PSI DWG # V049-8-575
LIGO-D961690-D-V

ITEM	QTY.	PART NO.	DESCRIPTION	PLT, 1.75 THK, 59.13 SQ., #43.5 ID
PART LIST			MATERIAL SPECIFICATION 304L SST	
UNLESS OTHERWISE SPECIFIED DIMENSIONS ARE IN INCHES TOLERANCES ARE: DECIMALS ANGLES FINISH .01 ± .01 ± 10° 125 JOB ± .005 //, C, L WITHIN .05 UNPROCESSED FLATS, RIMS BREAK EDGES, JOB & SST REMOVE ALL BURRS			CONTRACT OR SALES ORDER NO. APPROVALS DATE APPROVALS DATE THIRD ANGLE PROJECTION DO NOT SCALE DRAWING ENGINEER ZH 1-18-96	
GNB Corporation SCIENTIFIC AND INDUSTRIAL EQUIPMENT 30871 San Ramon Court MAYFIELD, CALIFORNIA 94544 (510) 441-1900 FAX: (510) 441-0830			TITLE PLATE, GATE SIDE FLANGE LIGO G44 (BW/FLG)	
D103797 USED ON			DWG. NO. 103798 SCALE: NONE SHEET 1 OF 1

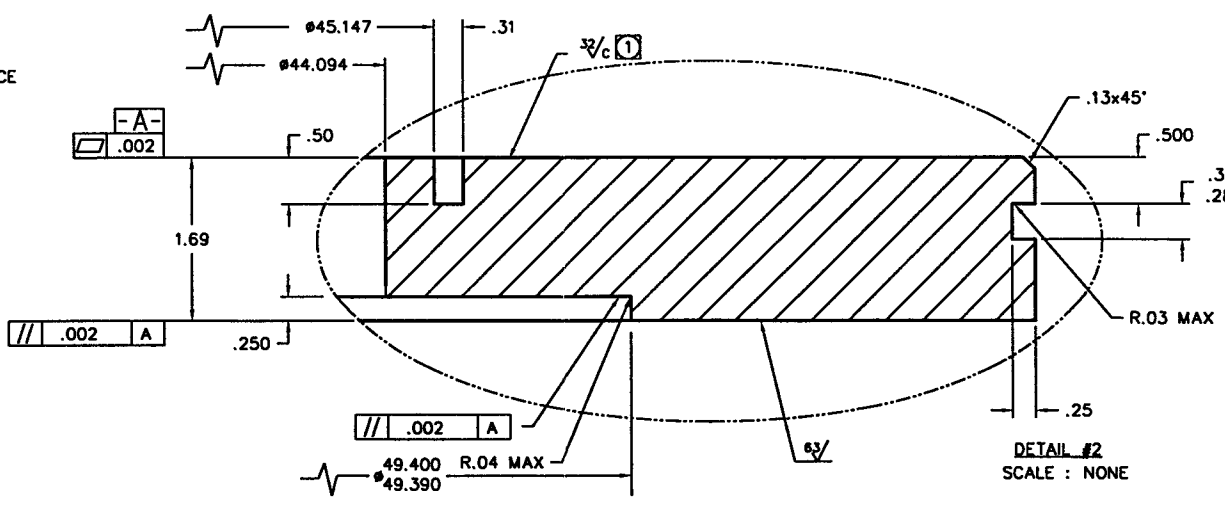
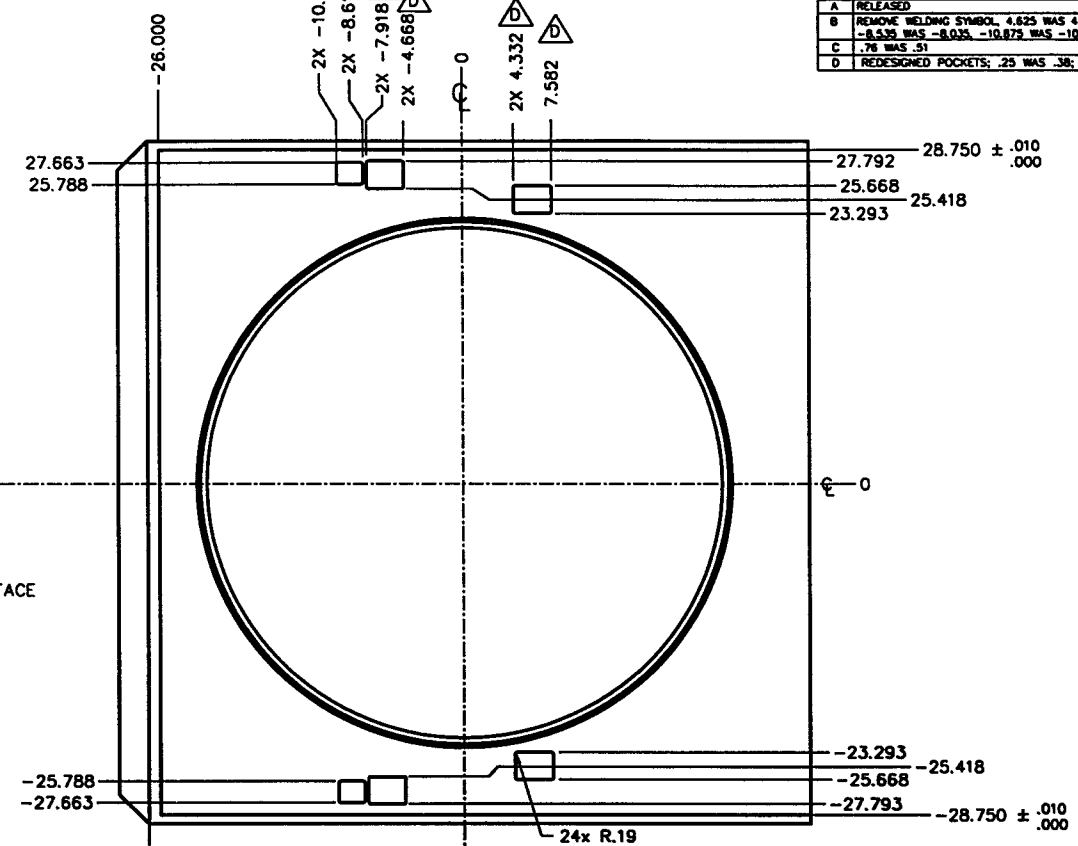
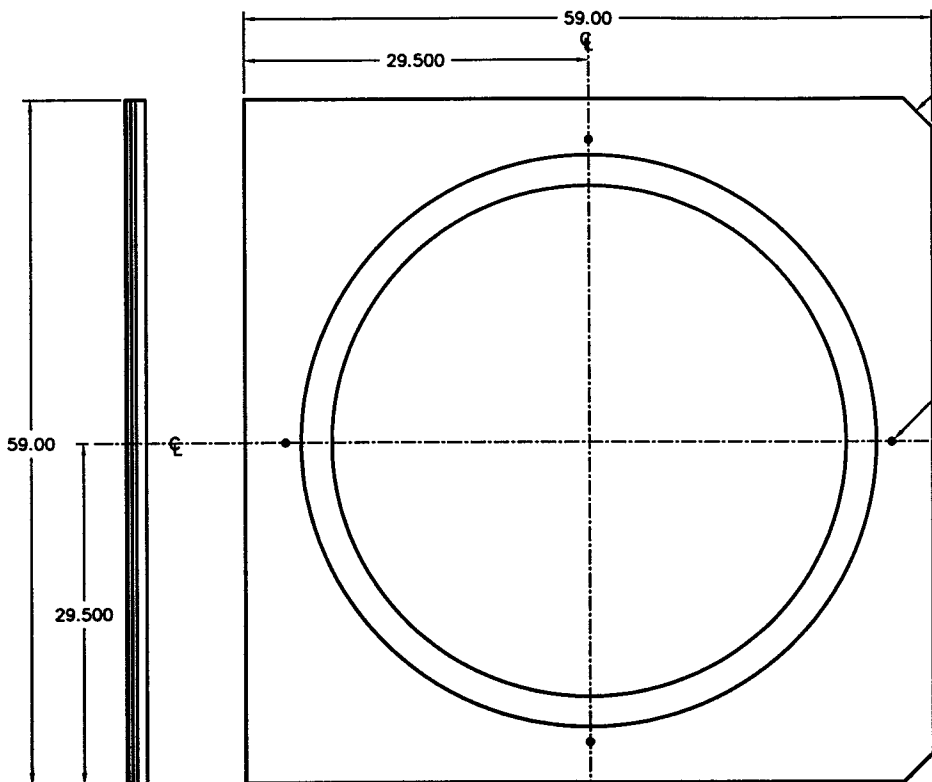
REV	DESCRIPTION	DATE
A	RELEASED	1-27-96
B	REMOVE WELDING SYMBOL, 4.625 WAS 4.125, 7.625 WAS 7.125, -8.535 WAS -8.035, -10.875 WAS -10.375	2-8-96
C	.76 WAS .51	10/19/96
D	REDESIGNED POCKETS; .25 WAS .38; ADDED ALIGNMENT HOLES	10/19/96
